SUBMITTAL TO THE FLOOD CONTROL AND WATER CONSERVATION DISTRICT BOARD OF SUPERVISORS COUNTY OF RIVERSIDE, STATE OF CALIFORNIA

SUBJECT: FLOOD CONTROL DISTRICT: Approve Addendum No. 1 to Plans and Specifications and Contract Documents; Accept Low Bid and Award the Contract for the Perris Valley Channel Lateral B, Stage 4, Project No. 4-0-00009-04, Nothing Further Required Under CEQA, District 1. [$20,503,846 Total Cost - District Funds 100%]

1. Approve Addendum No. 1 to the Plans and Specifications and Contract Documents issued prior to the July 24, 2025 bid opening;

Drawing No. 4-1170 Sheets 1 through 42

PROJECT NO.	4-0-00009
DRAWING NO.	4-1170
SHEET NO.	2 OF 42

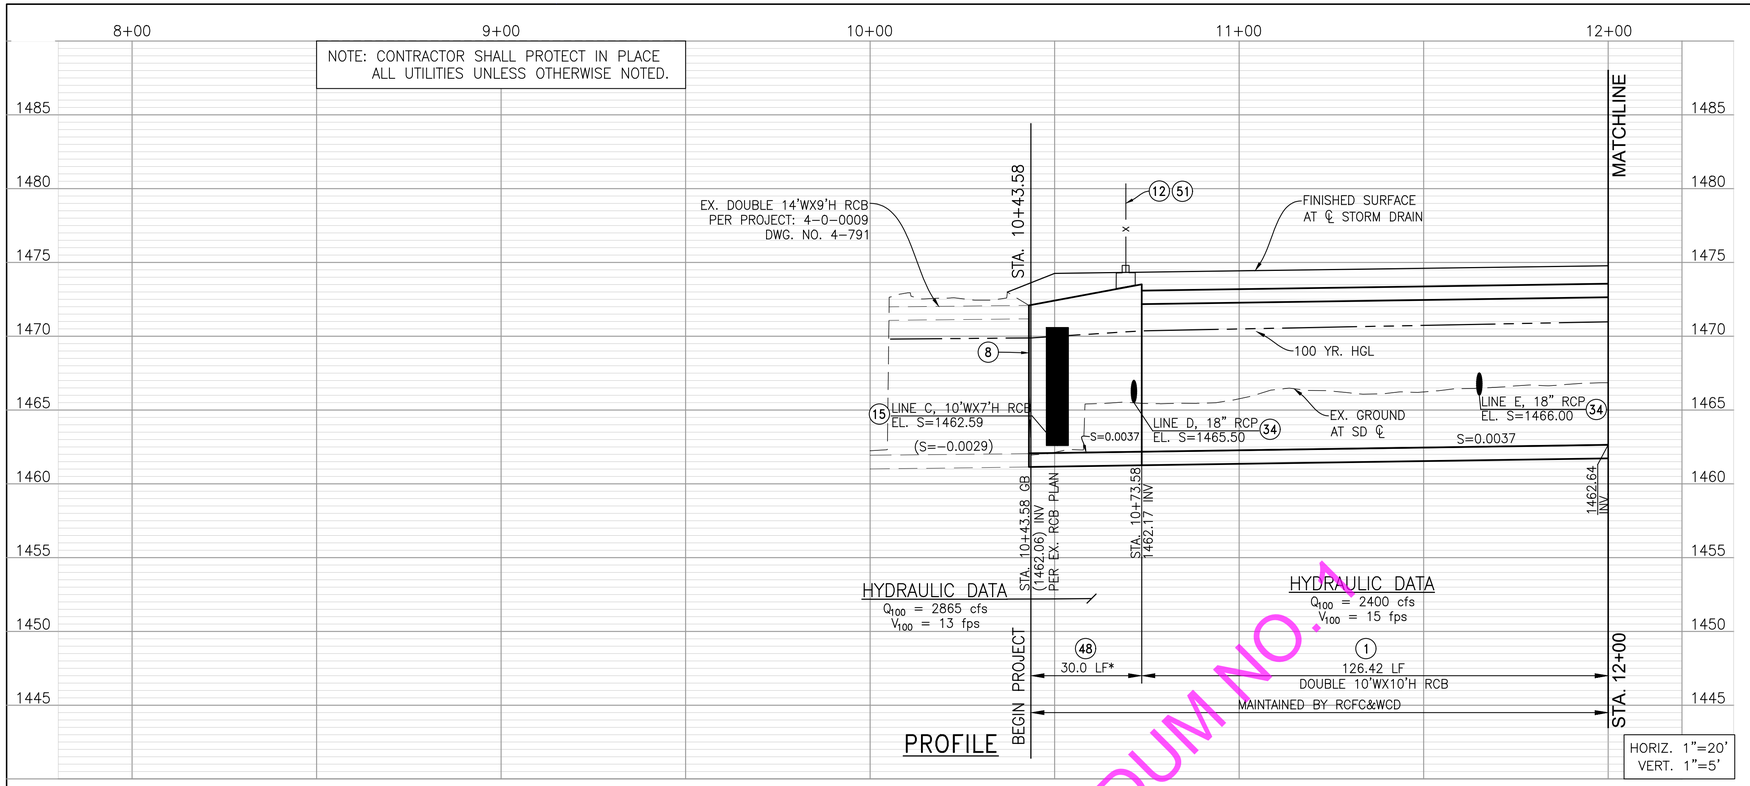
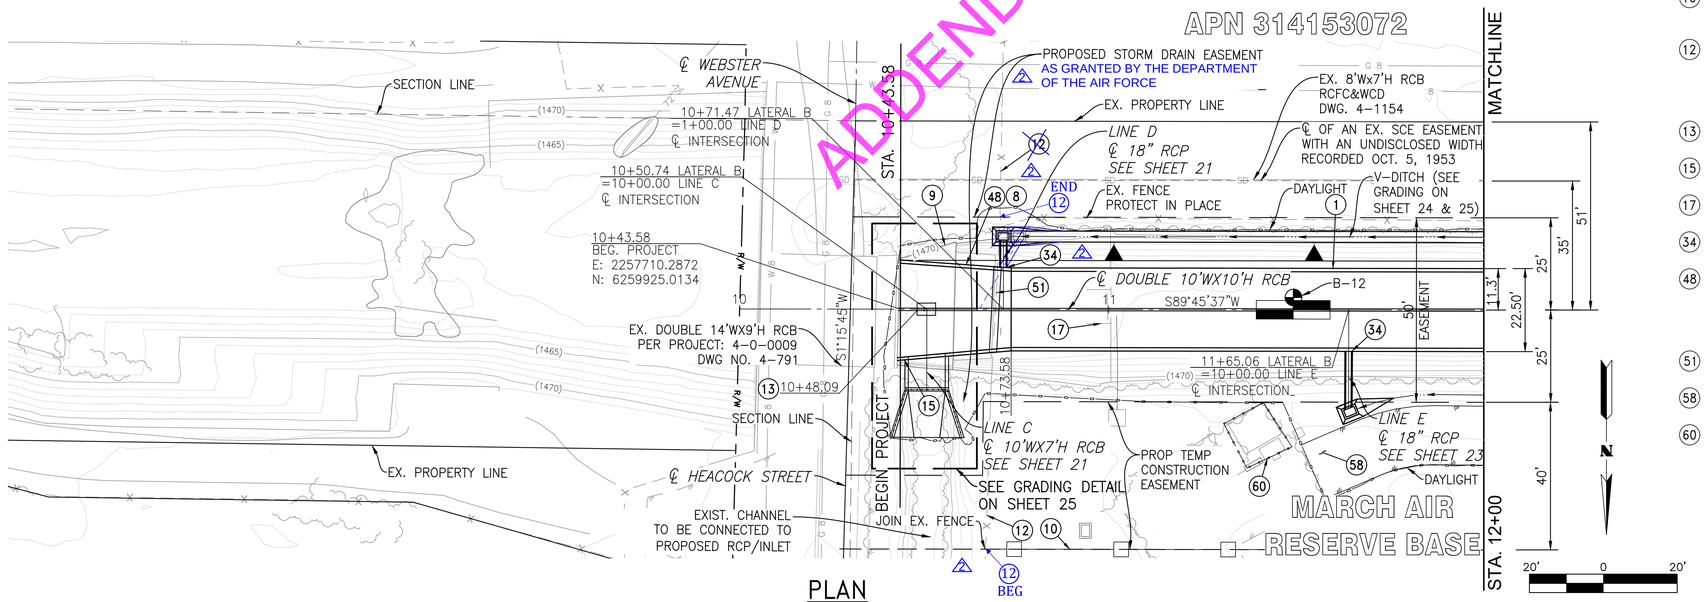
Answer	***Yes, nails can be used to connect the 2x4 frame for the temporary ILS zone fence.***
Question 62	What are the limits of the remove and replace with 7' high fence on sheet 2?

Question 77	Sheet 2 & 3, Protect existing fence Sta 10+43 to ~15+50 – existing fence on southside of channel cannot be protected in place because the new RCB is in the same alignment. Please provide bid item that this removal and replacement should be priced. As well as what temporary fence or other measures will be required.

Answer	***The plans have been updated to show the beginning and the end of the removal and replacement of the 7' Airforce Base Security Fence on Sheet 2. Line D grate inlet is moved 4 feet to west in order to avoid a conflict with the fence, please see updated plans Sheets 2, 21 and 25.***

Answer	***The plans and the typical sections at Sta 11+50 on Sheet 2 and at Sta 13+50 on Sheet 3 indicate the clearance between the RCB and existing fence is between 13' and 14.5'. The contractor will be required to protect existing fence on Sheets 2 and 3 in place.***

PROJECT NO. 4-0-00009
DRAWING NO. 4-1170
SHEET NO. 6 OF 42

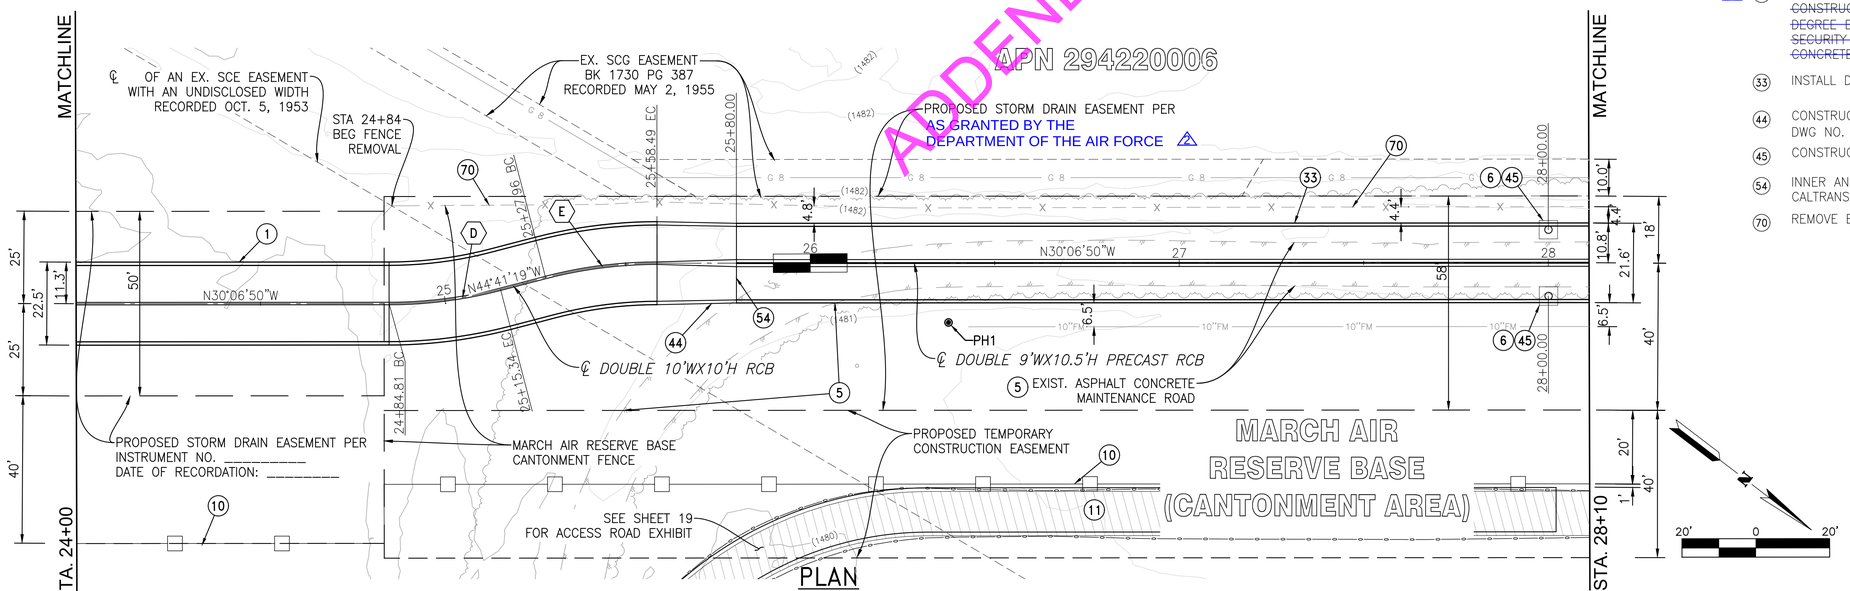
Question 63	Sheet 4 shows note number 12 in the legend, but there does not appear to be any callouts on the plan sheet. Please confirm that there is no 7' fence replacement on this plan sheet.

Answer	***Sheet 4 does not have Construction Note 12 in the legend, but Sheet 6 does. The plans will be amended to remove Construction Note 12 from Sheet 6.***

11. CONSTRUCT 12 FEET WIDE 3" THICK CLASS II BASE TEMPORARY MARB ACCESS ROAD, ROAD TO BE REMOVED AND SURFACE RESTORED TO ORIGINAL ELEVATIONS PRIOR TO FINALIZATION OF CONSTRUCTION. SEE SHEET 19 AND 20 FOR ACCESS ROAD EXHIBIT.
2 12. ~~REMOVE EXISTING FENCE & REPLACE WITH 7' HIGH (MATCH EXISTING AFTER CONSTRUCTION OF STAGE 4) AIRFORCE SECURITY FENCE WITH SINGLE 45 DEGREE BARBED WIRE ARM (BARBS AWAY FROM MARB) PER UFC 4-022-03 SECURITY FENCE & GATE SPECIFICATIONS & DWG. NO. UFC 700. MODIFIED CONCRETE CURB PER DETAIL ON SHEET 34~~

PROJECT NO. 4-0-00009
DRAWING NO. 4-1170
SHEET NO. 26 OF 42

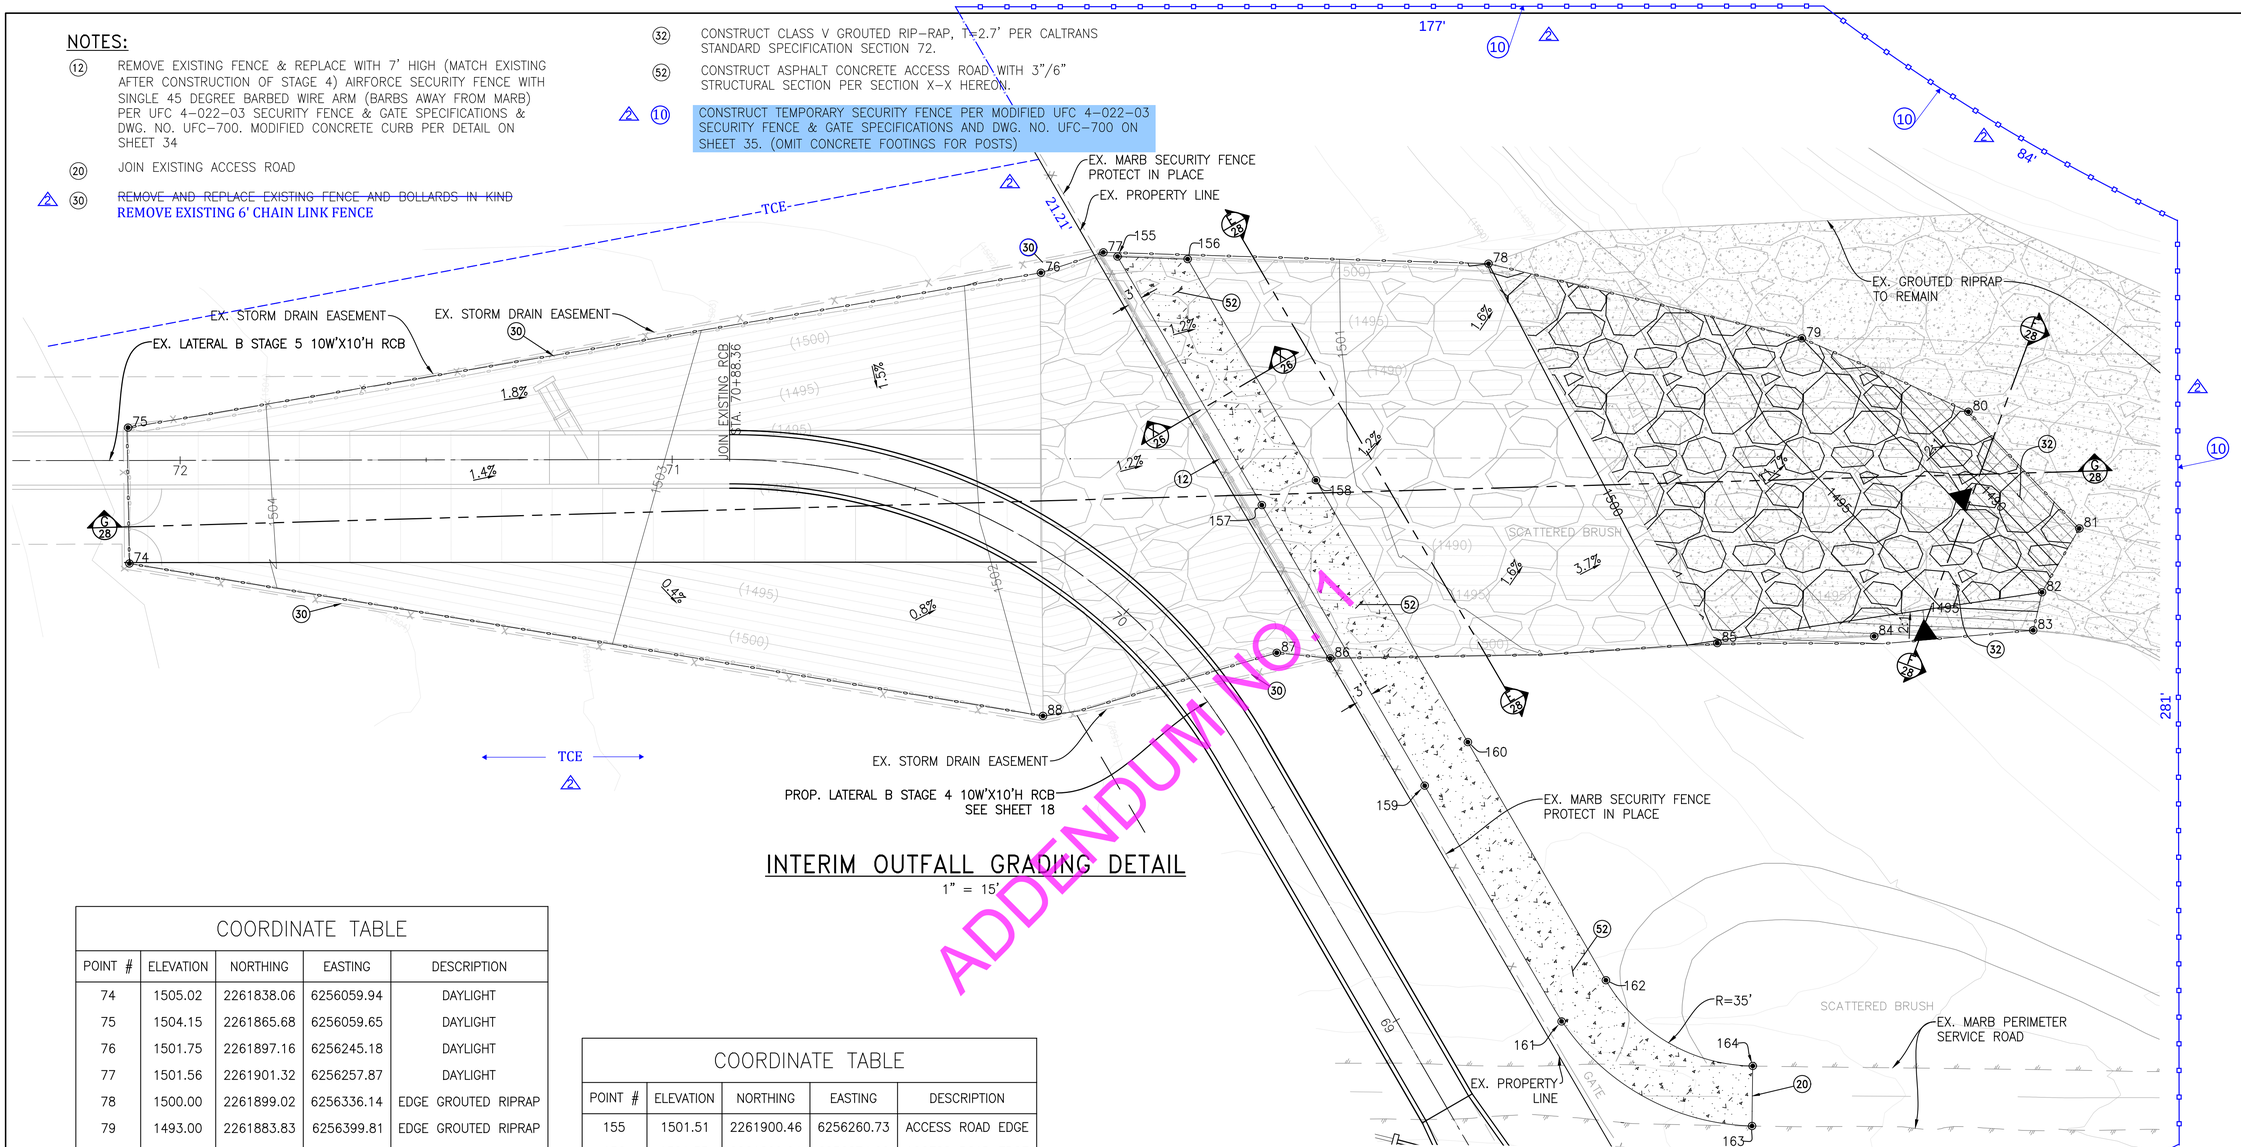
Answer	***The District does not find rescheduling bid due date feasible at this time.***
Question 22	Sheet 26, detail #30 – Remove and replace fence/bollards in kind ~ 500LF. Please provide details for type of fence, type of bollard and Qty of both.

Answer	***Sheet 26, Construction Note No.30 shall read " Remove Existing 6' Chain Link Fence". Updated Plans will be posted along with the responses to bidders' questions.***

(2) (30) ~~REMOVE AND REPLACE EXISTING FENCE AND DOLLARDS IN KIND~~
REMOVE EXISTING 6' CHAIN LINK FENCE

PROJECT NO.	4–0–00009
DRAWING NO.	4–1170
SHEET NO.	30 OF 42

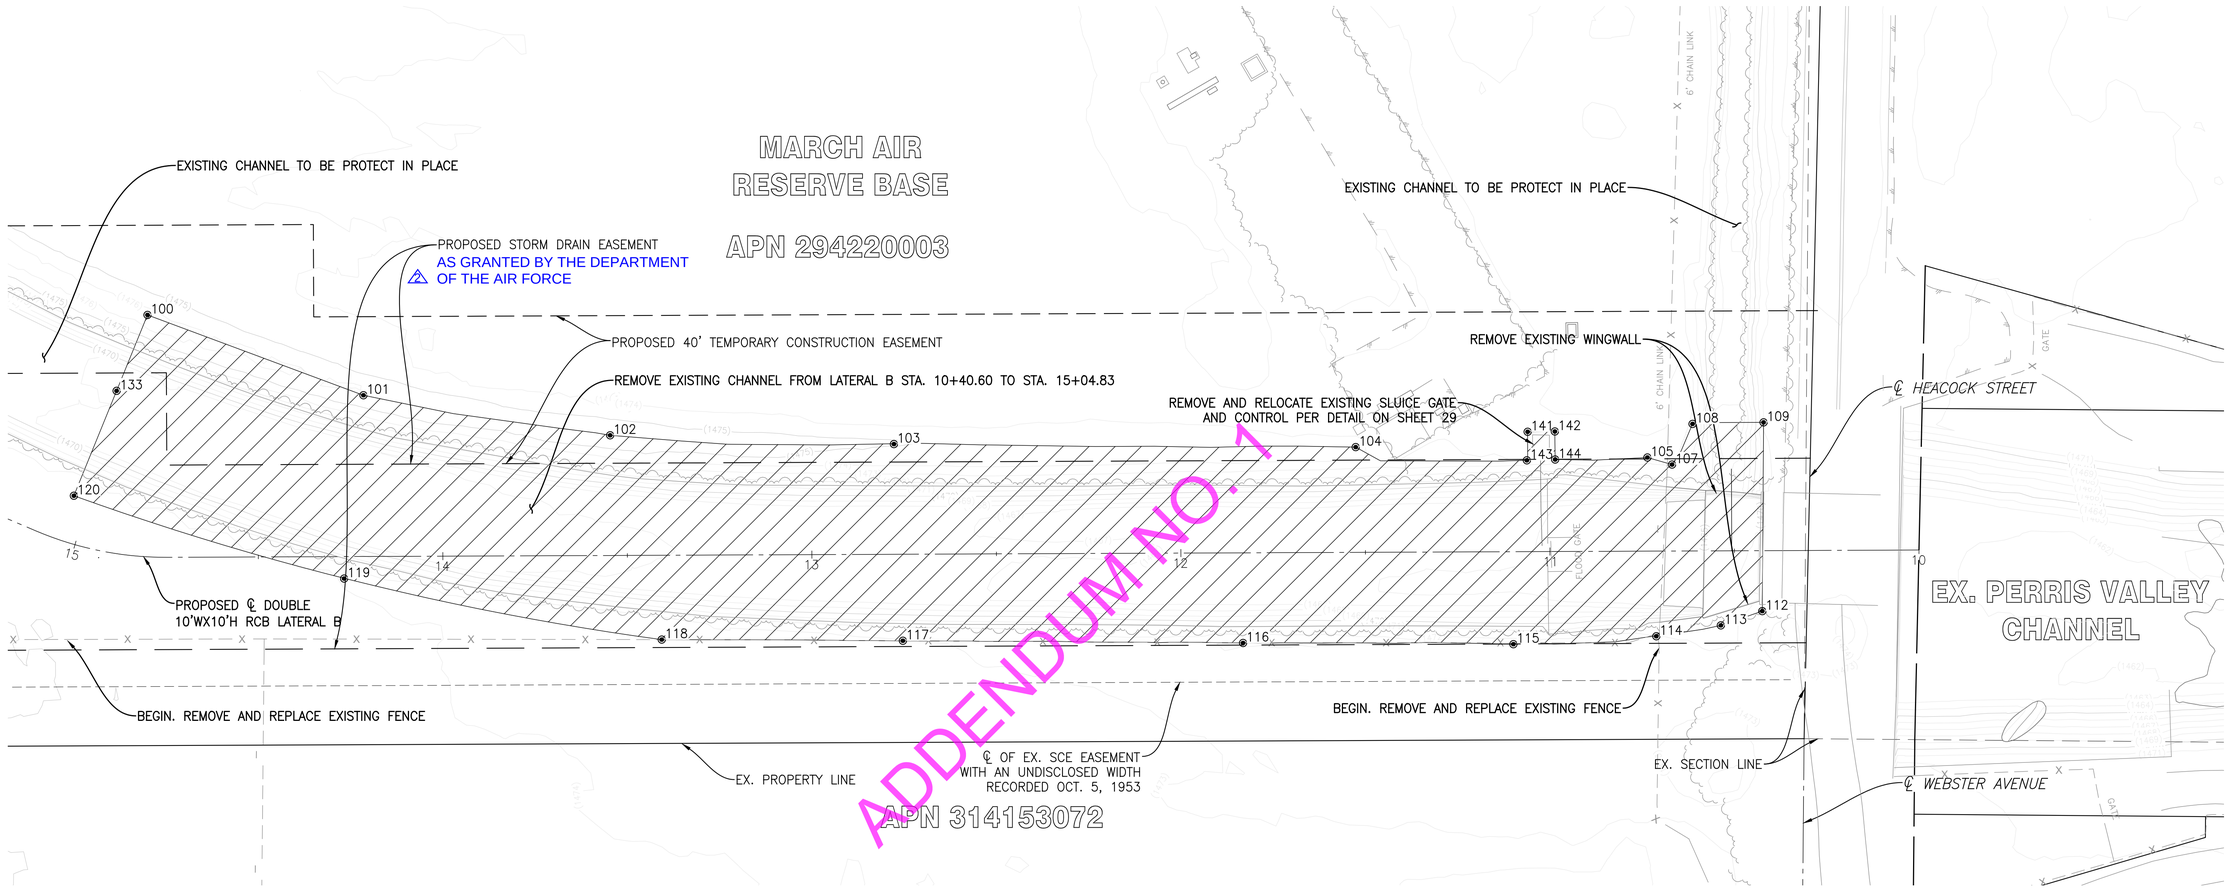
Question 74	On the Plan Sheet 30/42 for the detail of the DBL Precast RCB, can the Contractor eliminate the 3" Gap in between the Units and place the Precast RCB Side by Side?

Answer	***No, the 3" gap filled with CLSM between the units cannot be eliminated. Caltrans Standard Drawing D83B was followed in specifying the gap.***

PROJECT NO. 4-0-00009
DRAWING NO. 4-1170
SHEET NO. 31 OF 42

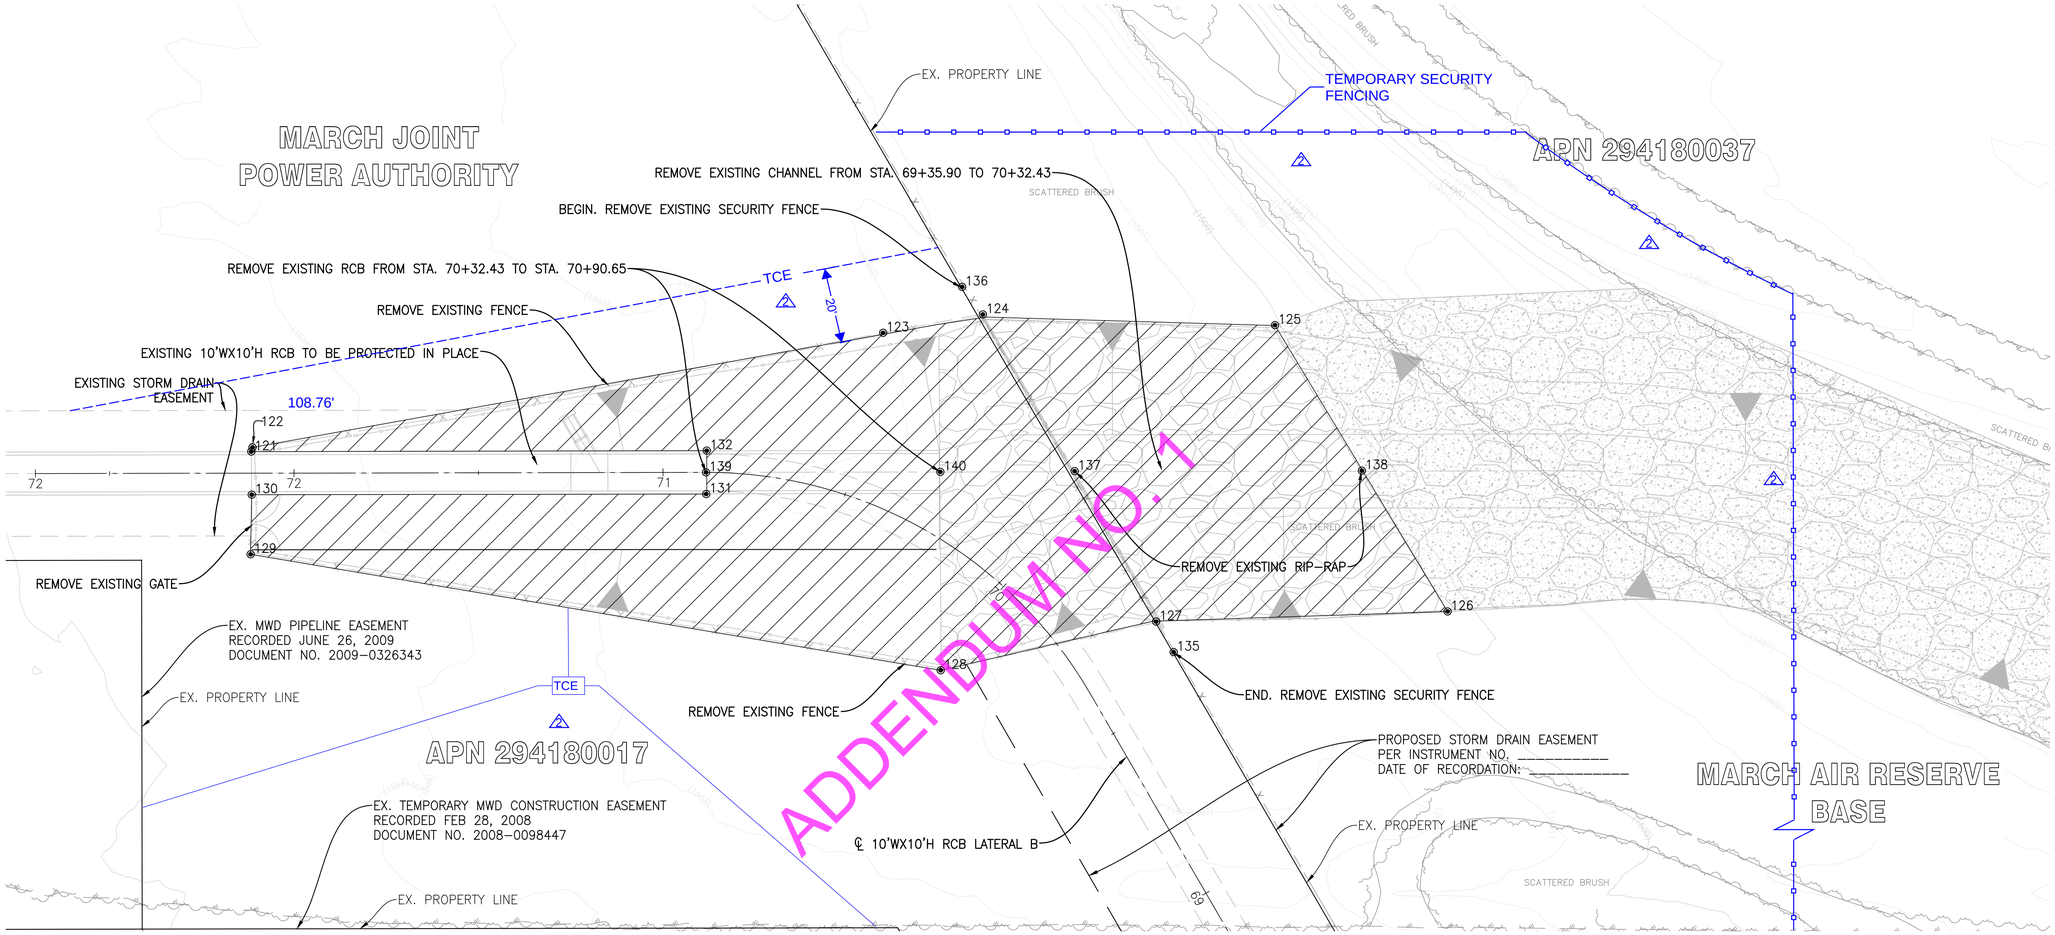
Question 15	Plan sheets 31 & 32 both indicate removing significant portions of the existing channel. Please provide as-builts and/or additional details so the full extent of the removals can be quantified.

Answer	***<u>Sheet 31</u> - There are no as-built plans available for the existing channel shown on Sheet 31. The existing channel is concrete lined with pieces of broken concrete slab grouted with concrete. For bidding purposes please consider the following channel dimensions: bottom width 25 feet, depth of the lined slope 4 feet, sideslopes 1.5:1 and thickness of the lining 6 inches. A picture of the existing channel is included at the end of the responses.*** ***<u>Sheet 32</u> - The upstream end of the project connects to the existing Stage 5 of Perris Valley Channel Lateral B. Please refer to District DWG No. 4-1158 for as-built plans of Stage 5. Bidders' attention is directed to Sheets 2, 3, 4, 27 and 28 of said as-built plans. DWG No. 4-1158 will be posted along with these responses and available for download. (DWG 4-1158 is referenced on Sheet 18 of the current bid plans).***
